UNITED STATES
NUCLEAR REGULATORY COMMISSION

SUBJECT: ISSUANCE OF AMENDMENT NO. 48 TO FACILITY OPERATING LICENSE NPF-18
LASALLE COUNTY STATION, UNIT 2 (TAC NO. 62832)

This amendment revises the LaSalle County Station, Unit 2 Technical Specifications to allow use of high density fuel racks in Unit 2.

FIGURE 7

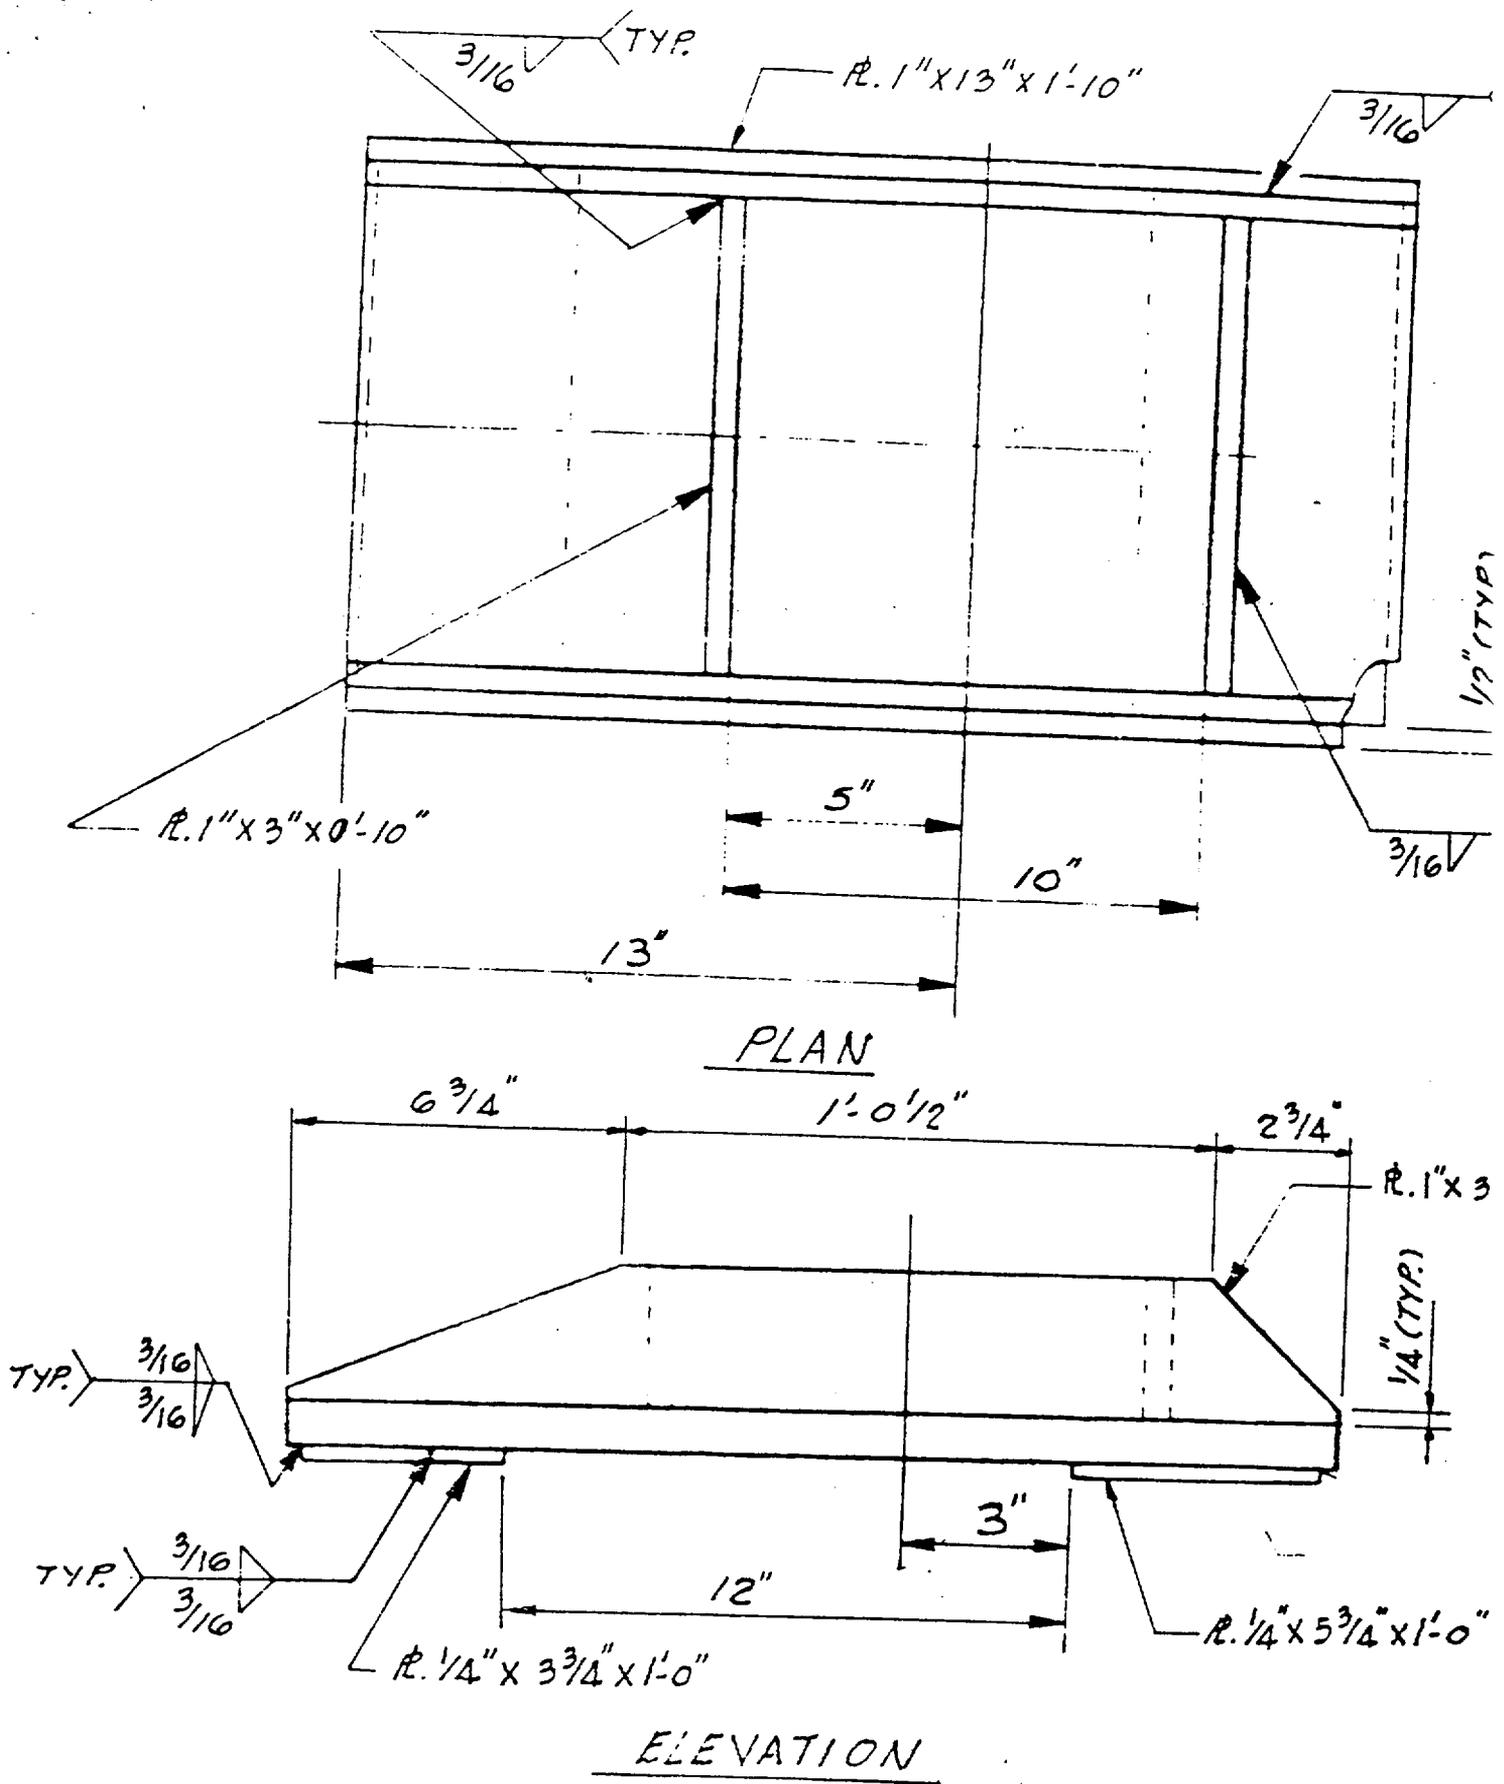
The replacement high density spent fuel racks will rest on bridge plates (Figure 7) on the pool floor. The bridge baseplates span seam welds on the pool floor. The bridge plates are not attached to the pool floor but have collars which engage the feet they support. The baseplates were not included in the rack model but were assumed to move with the rack. The baseplates are large enough to accommodate the possible slippage of the fuel racks during an earthquake without coming in contact with the liner seams.

FIGURE 14

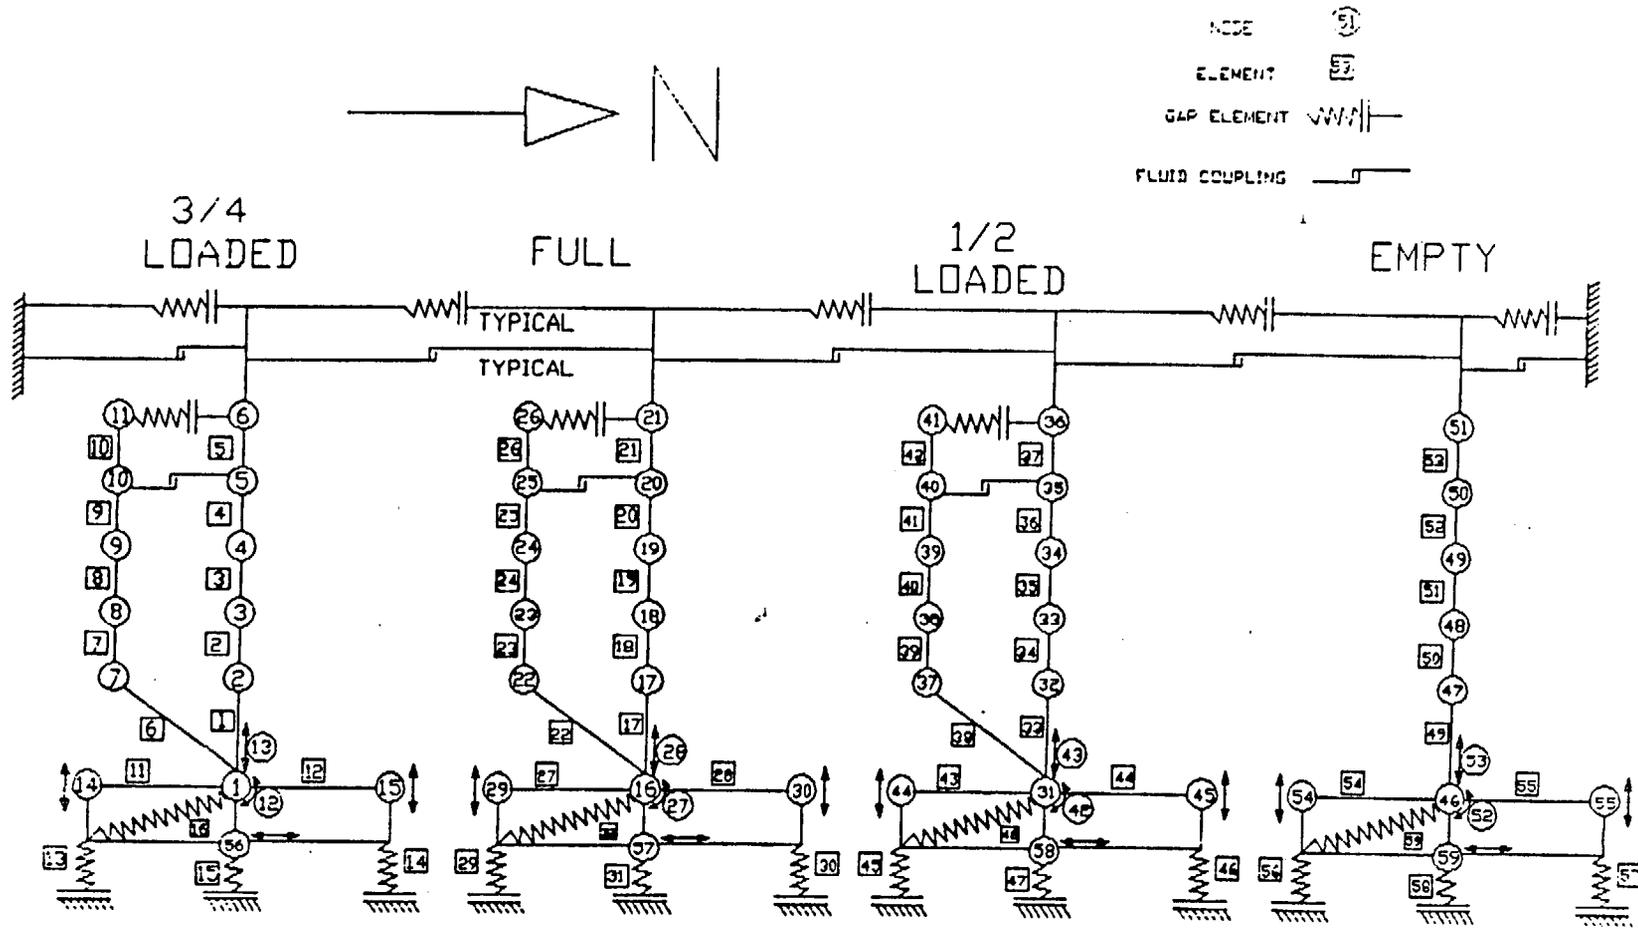
The 2-D multi-rack model shown in Figure 14 was analyzed with the RACKOE computer program, which was developed and verified by U.S. Tool and Die (UST&D). The analysis was performed for the combination of SSE and SRV since the higher seismic level will control the dynamic response. The North-South time history and the vertical time history were applied simultaneously. These time histories are the same as those utilized for the initial 3-D single rack analysis (see section 4.1.5).

The impact forces for the multi-rack analysis were much smaller than the forces from the initial 3-D analysis and the refined 3-D analysis. This is probably due to having only a 2-D model and 2-D input time history. The addition of the third input simultaneously, would increase the response, particularly if tilting occurs about both horizontal axes thereby causing torsional rotation about the vertical axis as well.

A review of the displacement time history response did show movement for all four racks in the North direction until impact with the North wall occurred. In addition, the motion of the three racks having partial and full fuel assemblies were very similar indicating strong hydrodynamic coupling effects while the empty rack motion was more erratic with very little correlation to the other three rack motions.

REINFORCEMENT PLATE DETAILS

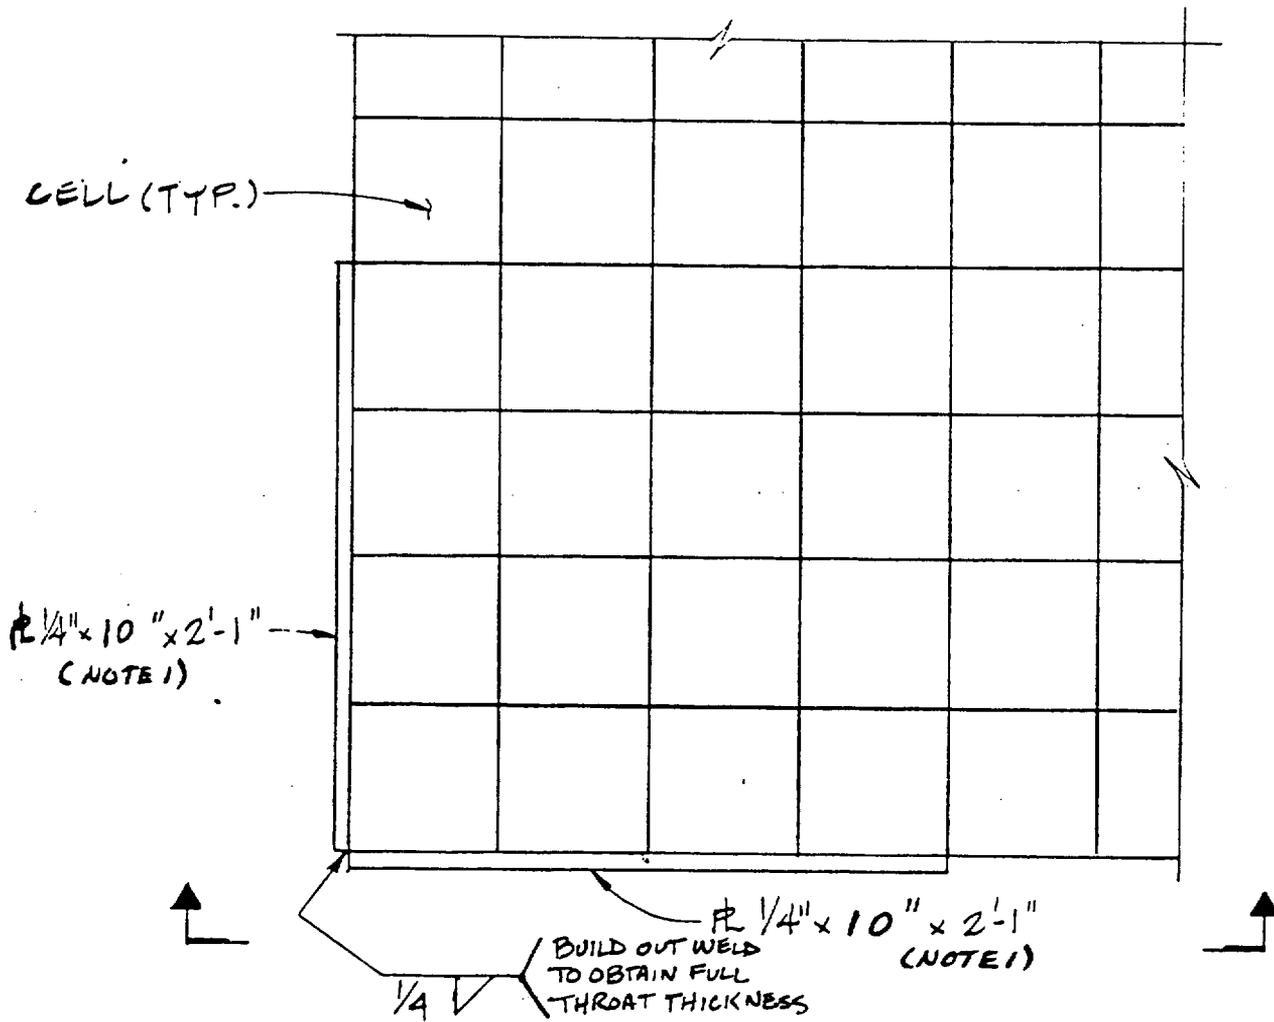
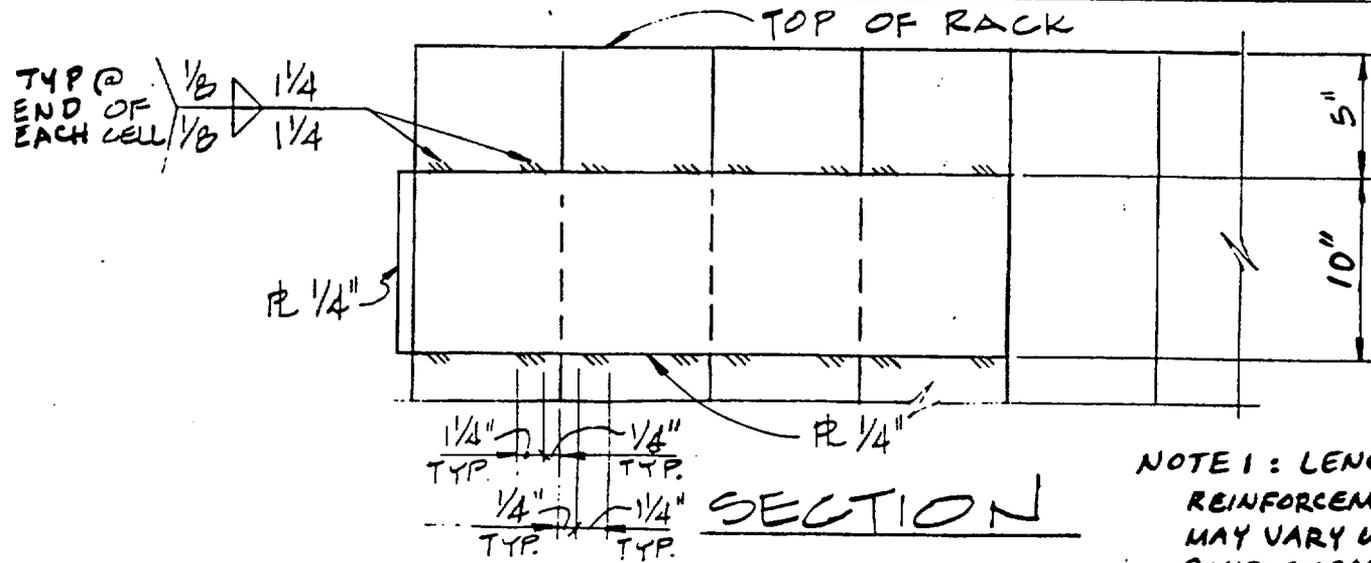
The rack to wall impact was judged to be more critical for the rack adequacy than the rack to rack impact since there is more flexibility in impacts between two racks. A detailed 2-D model representing the cells near the top of the rack was developed to analyze the local effects of the impact force. This model is shown in Figure 15. As a result of this analysis, the compressive stresses in some cell walls exceeded the allowable buckling stress. Thus, the Licensee proposed to install reinforcement plates as shown in Figure 16, to distribute the impact force over a sufficient number of cells where the compressive stresses are low enough.

With the addition of the 1/4" thick reinforcement plates as shown on Figure 16, the impact capacity of the racks has been demonstrated to be acceptable.

FUEL POOL STRUCTURE

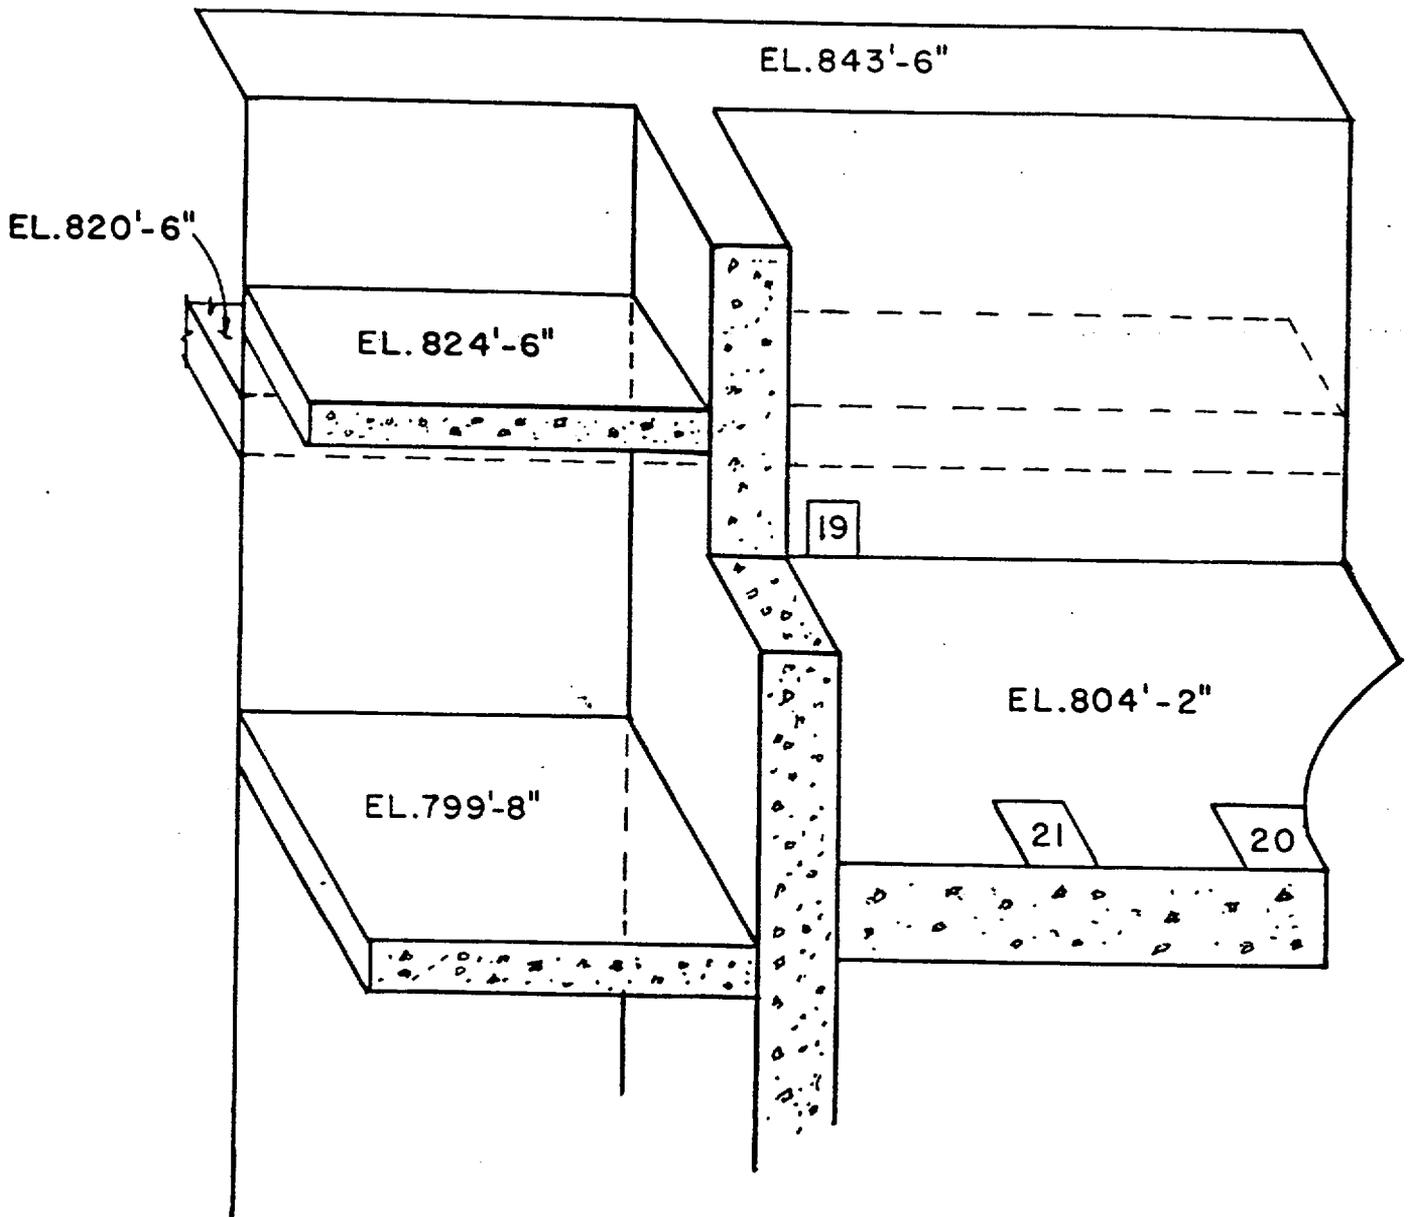
S&L performed an independent evaluation of the LSCS pool for the high density spent fuel rack loads including rack fluid coupling forces and wall impacts. This evaluation considered the critical section identified by SWEC in their evaluation and sections determined to be critical in the initial pool design. The critical sections are shown in Figure 17. The evaluation considered the load combinations shown in the FSAR and the DAR including the load combinations determined to be critical by SWEC in their evaluation.

The results of the evaluations performed by SWEC and S&L provide good assurance that the pool structure is capable of supporting the new high density racks filled with normal weight fuel.
